BROWNS FERRY NUCLEAR PLANT (BFN) – UNITS 1, 2, AND 3 – TECHNICAL SPECIFICATIONS (TS) CHANGES TS-418 AND TS-431 – EXTENDED POWER UPRATE (EPU) – RESPONSE TO ROUND 23 REQUEST FOR ADDITIONAL INFORMATION (RAI) REGARDING STEAM DRYER SIGNAL PROCESSING (TAC NOS. MD5262, MD5263, AND MD5264)

**TENNESSEE VALLEY AUTHORITY
BROWNS FERRY NUCLEAR PLANT (BFN)
UNITS 1, 2, AND 3**

**TECHNICAL SPECIFICATIONS (TS) CHANGES TS-431 AND TS-418
EXTENDED POWER UPRATE (EPU)**

**RESPONSE TO ROUND 23 REQUEST FOR ADDITIONAL INFORMATION (RAI)
REGARDING STEAM DRYER SIGNAL PROCESSING**

Figure EMCB.202/163-1a. Cross Spectra for BFN1 main steam line A: magnitude (top) and phase (bottom) for CLTP conditions (black) and corresponding EIC magnitude (red).

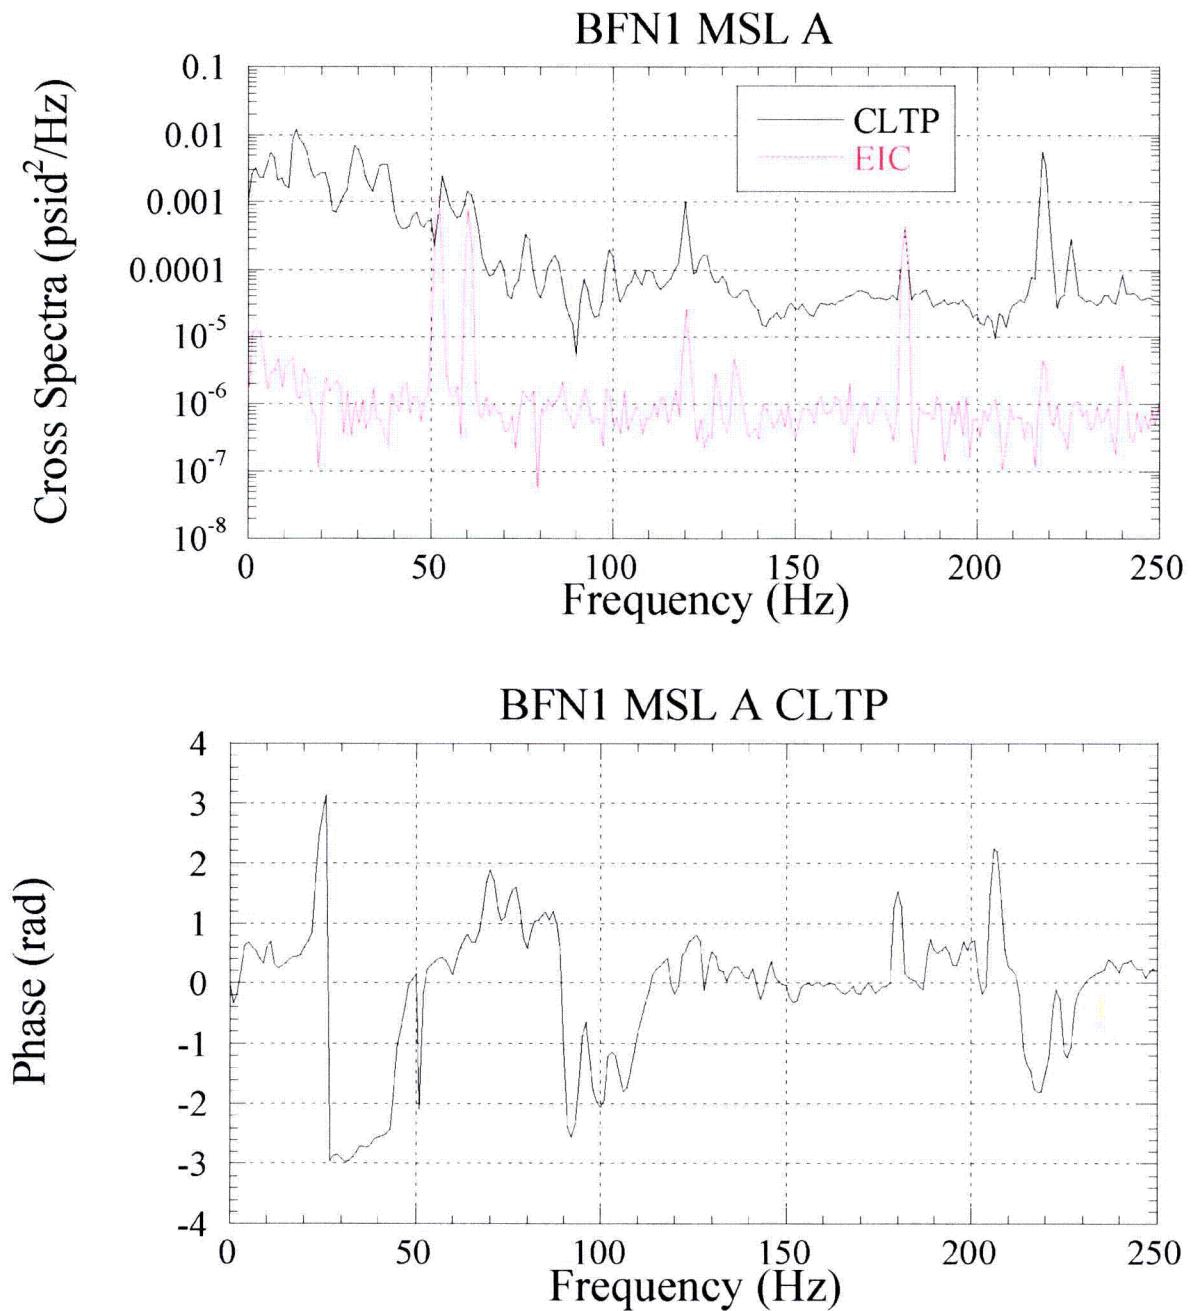
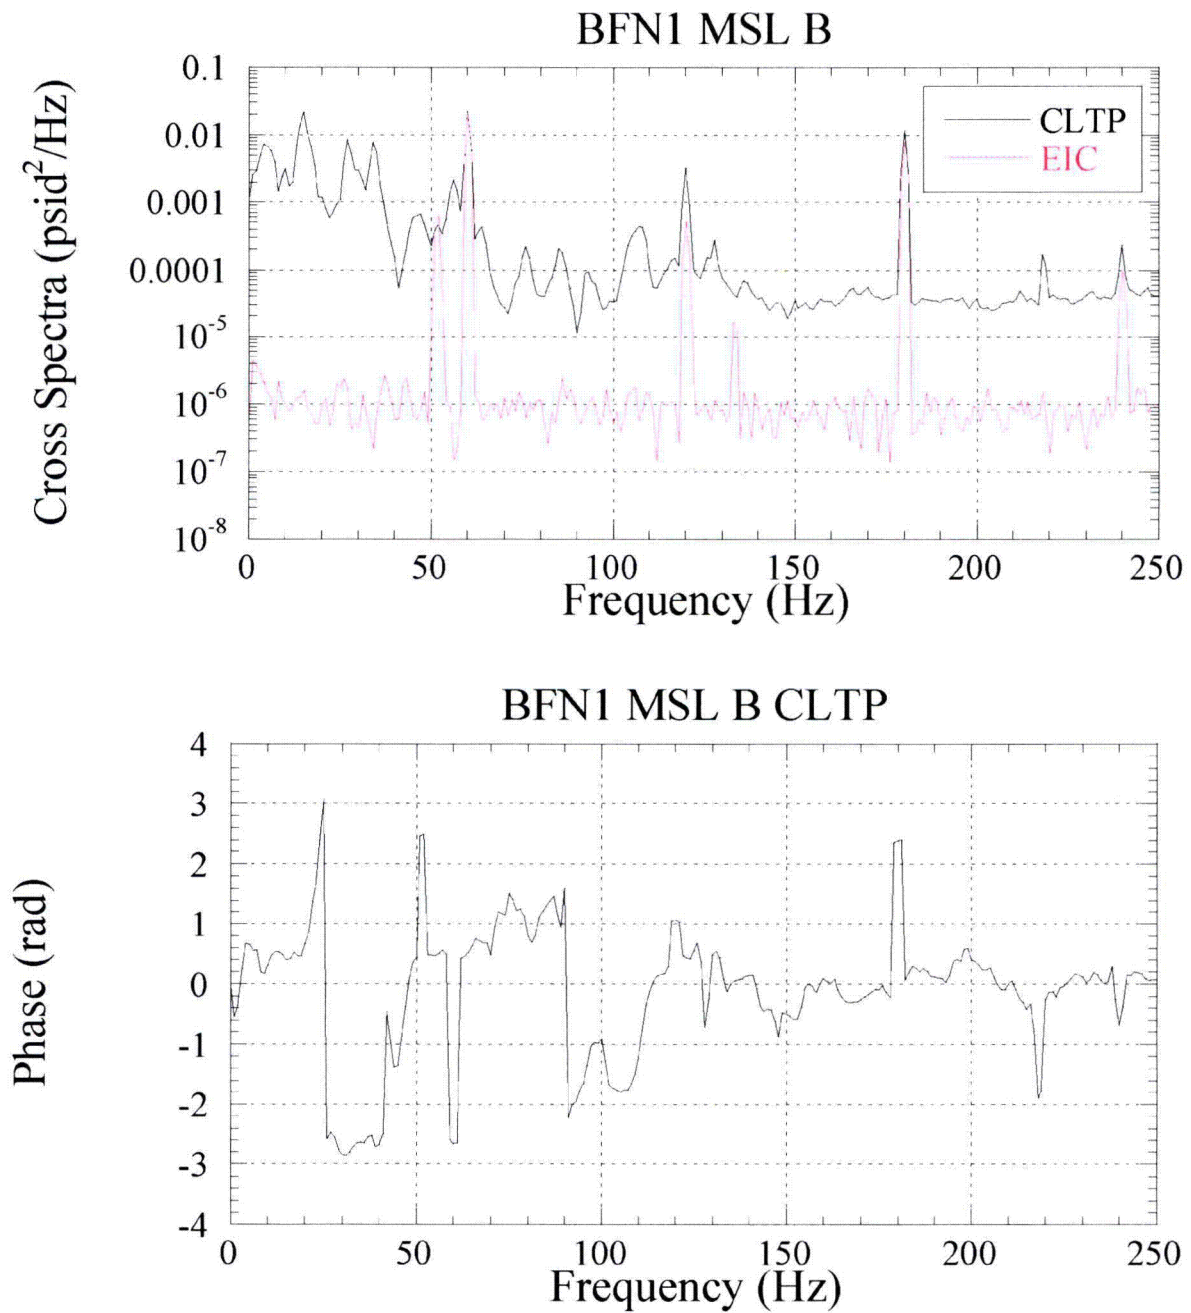
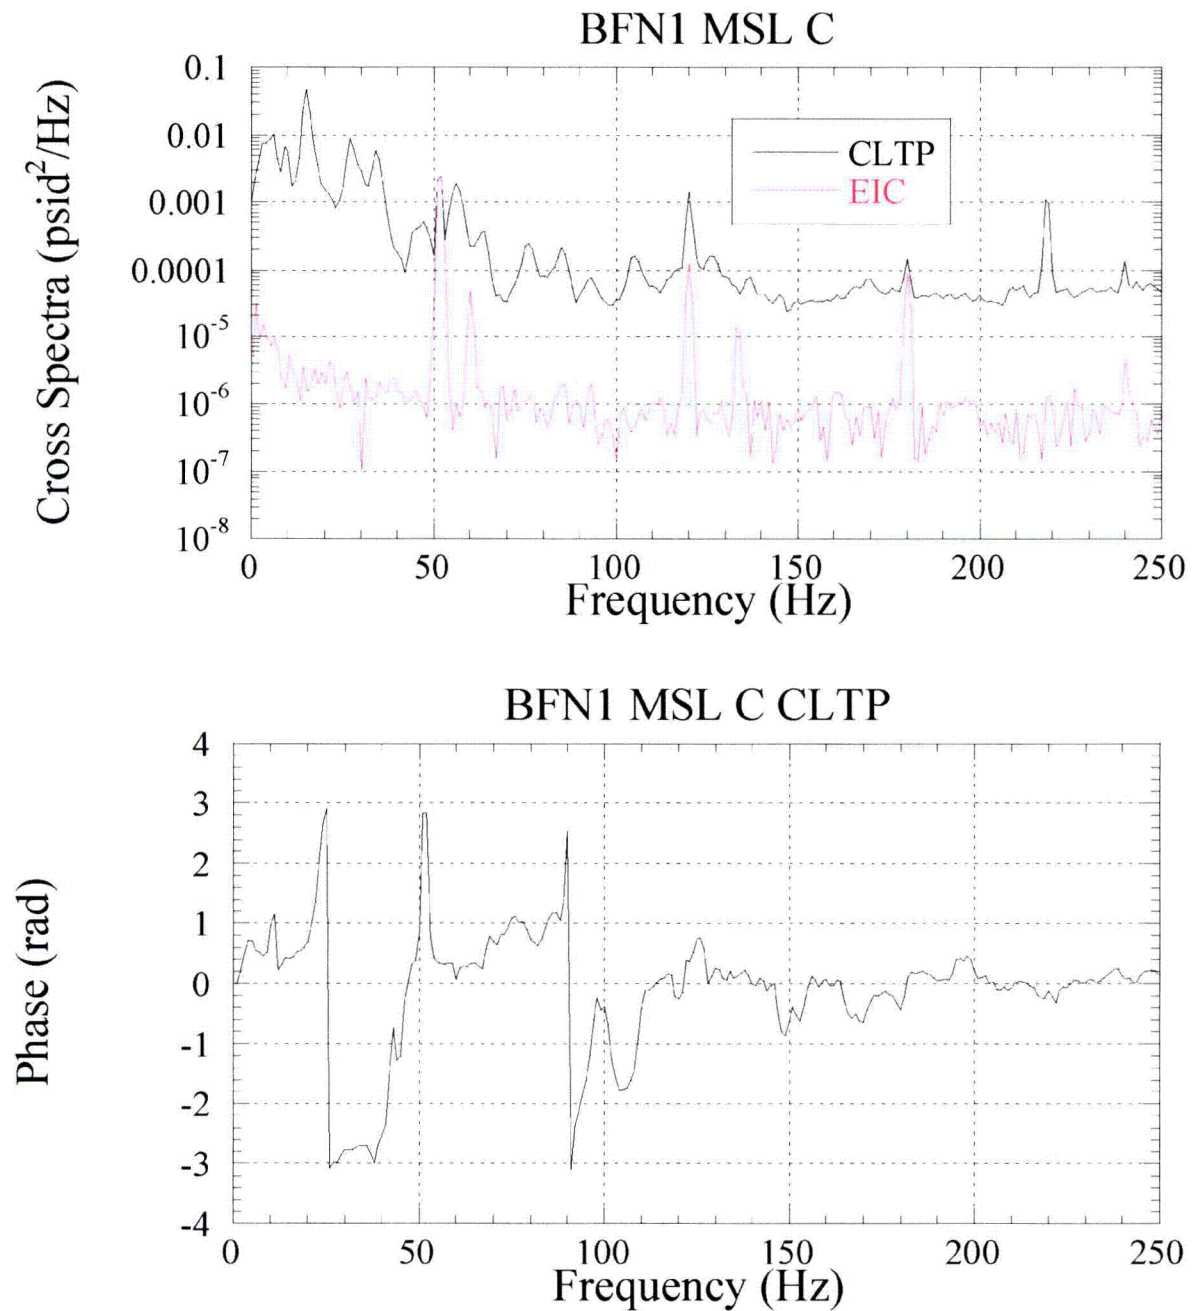
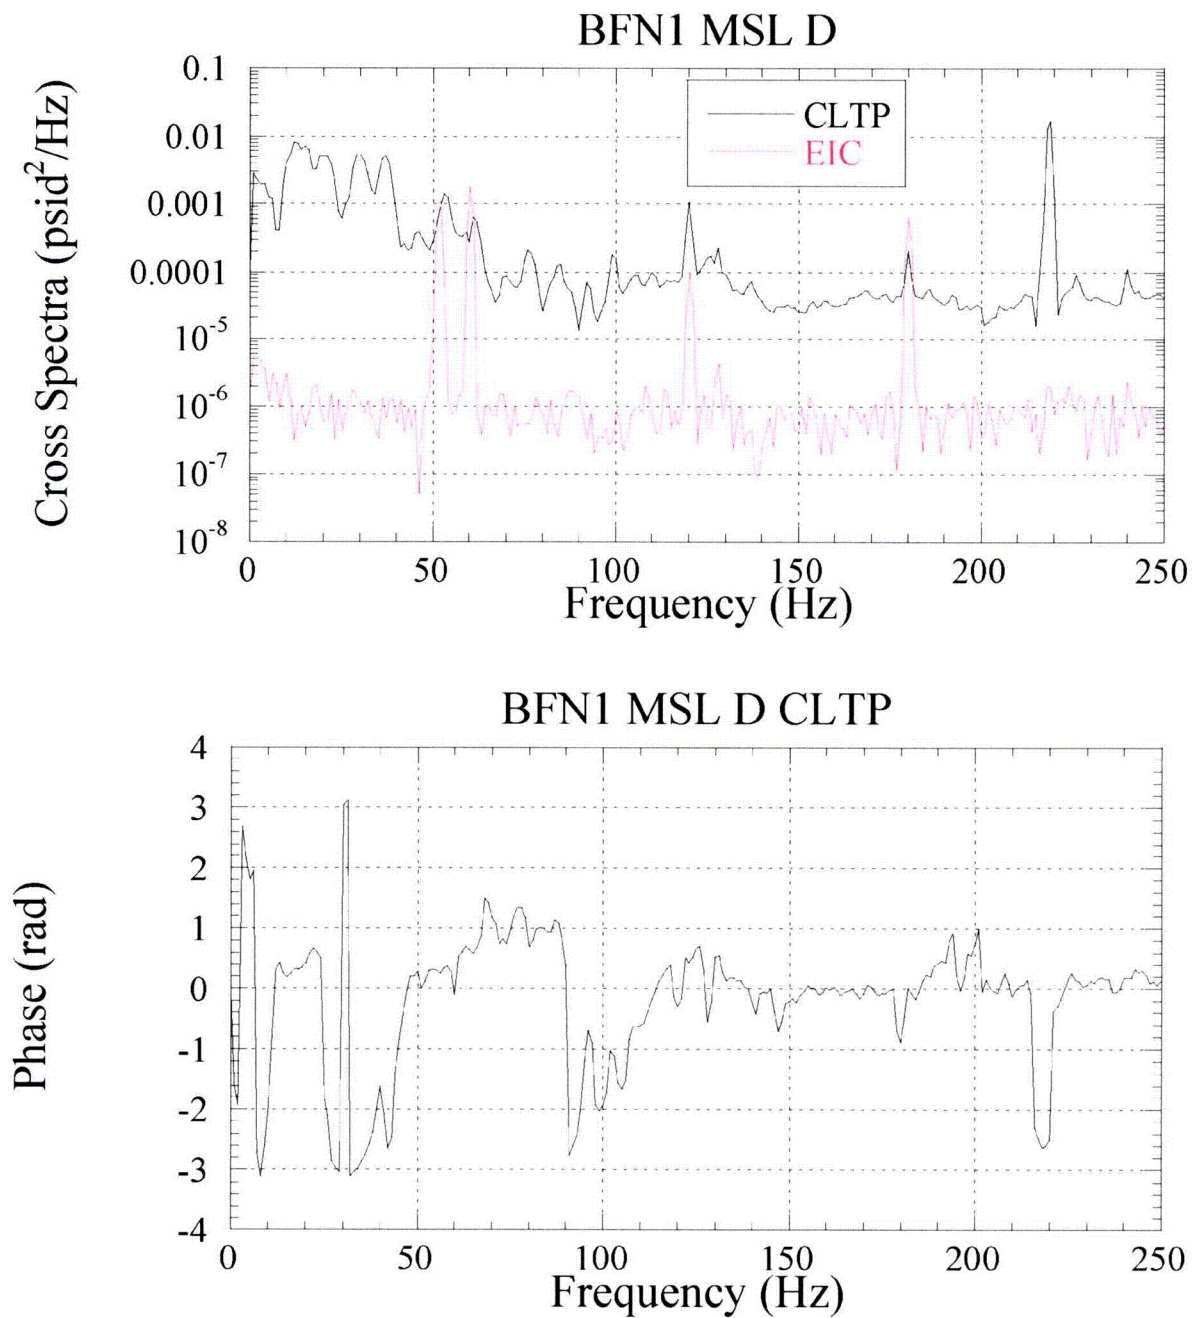
where G_{12} is the cross-spectrum between the two signals, and G_{11} and G_{22} are the autospectra of the individual signals. Explain how G_{12} is modified after using EIC signals and notch filters prior to being used in the coherence calculation. This explanation should include how both the magnitude and phase of G_{12} are modified.

To see how the magnitude and phase of G_{12} are modified, see Figures EMCB.202/163-1a through 1d where the CLTP and corresponding electrical interference check (EIC) cross spectra magnitude and CLTP cross spectra phase between upper and lower raw data from the steam lines are shown. The phase of the EIC cross spectra is not shown as it is randomly distributed in frequency.
